TRANS/WP.29/862  
18 July 2002

World Forum for Harmonization of Vehicle Regulations (WP.29)

DRAFT SUPPLEMENT 7 TO THE 09 SERIES OF AMENDMENTS  
TO REGULATION No. 13

(Braking)

"Figure 1B

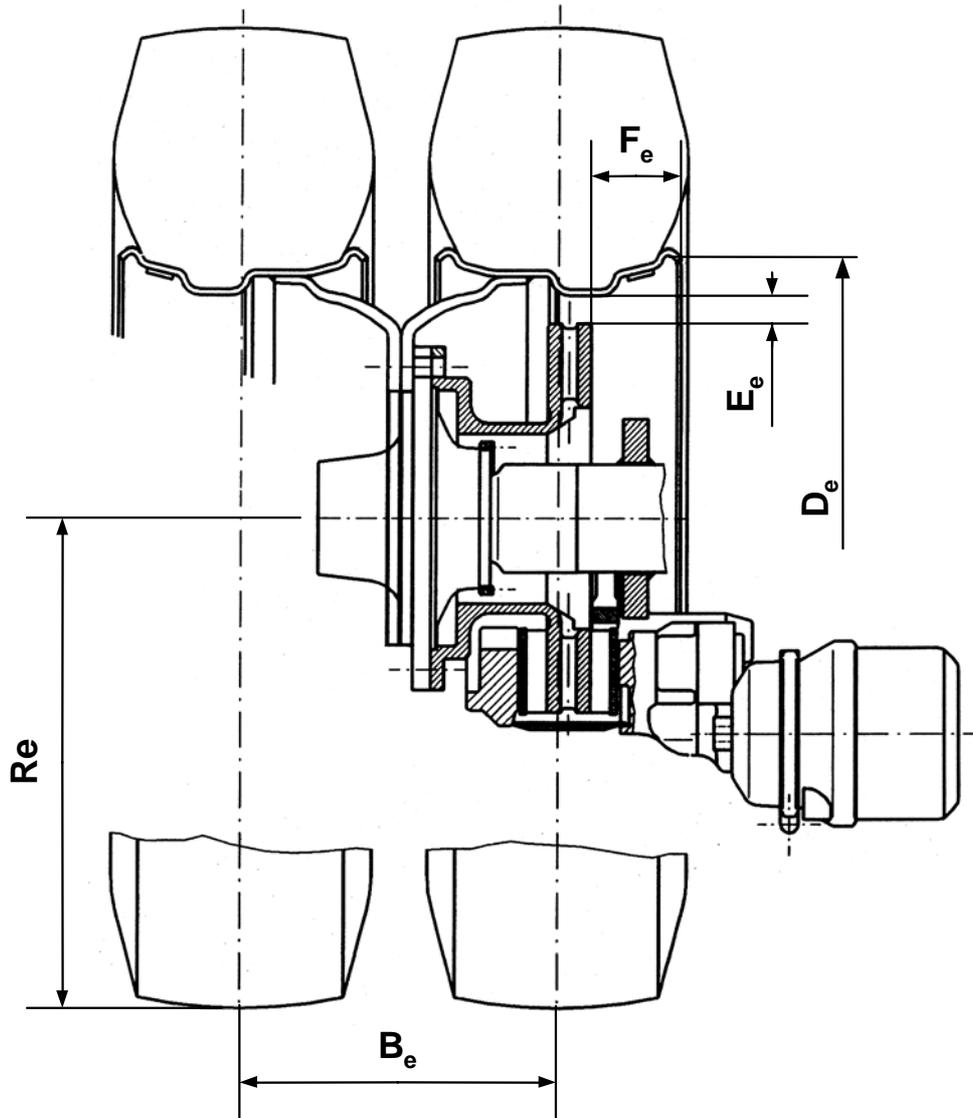
Insert a new Figure 1B for disc brakes, to read:

Be (mm)	De (mm)	Ee (mm)	Fe (mm)	Re (mm)

“Figure 2B

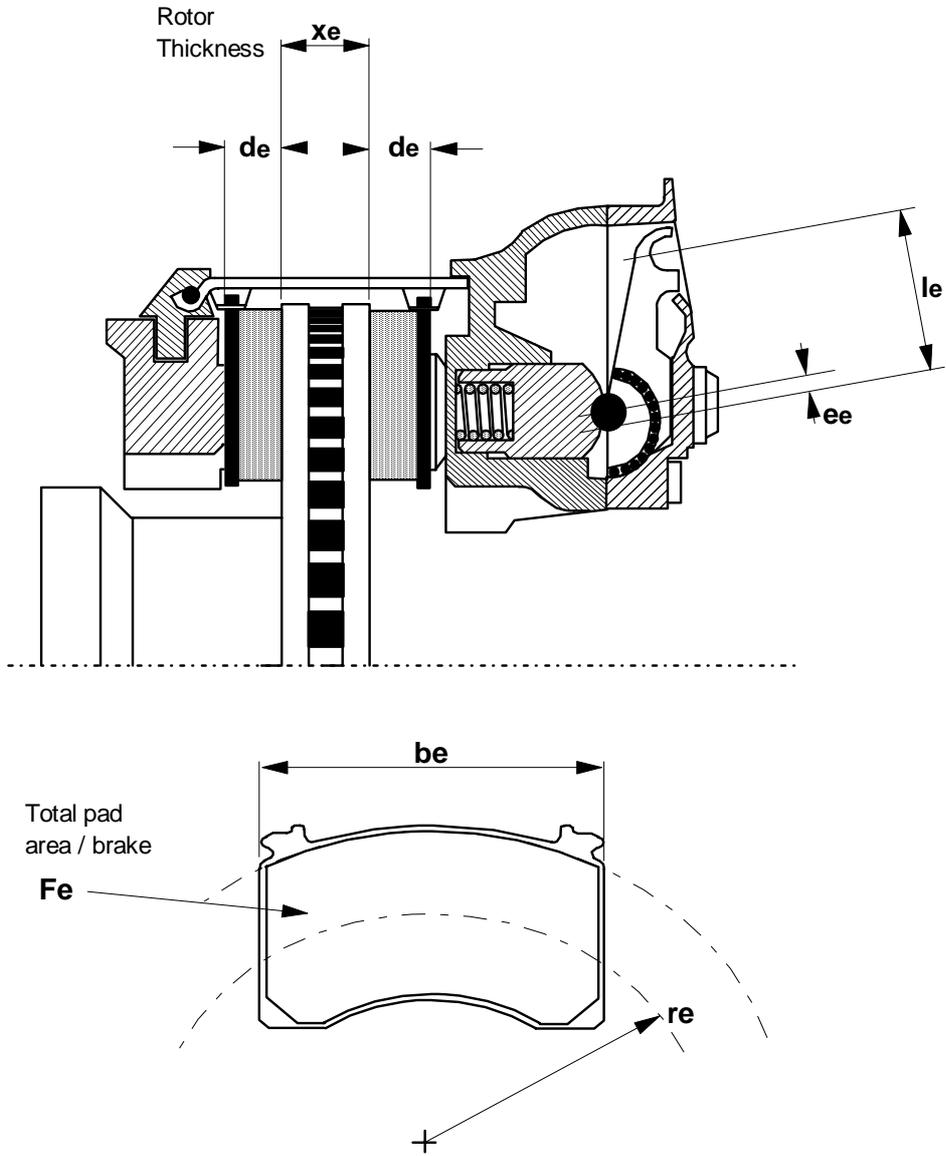
Insert a new Figure 2B for disc brakes, to read:

$l_e$ (mm)	$e_e$ (mm)	$d_e$ (mm)	$x_e$ (mm)	$r_e$ (mm)	$b_e$ (mm)	$F_e$ ( $cm^2$ )
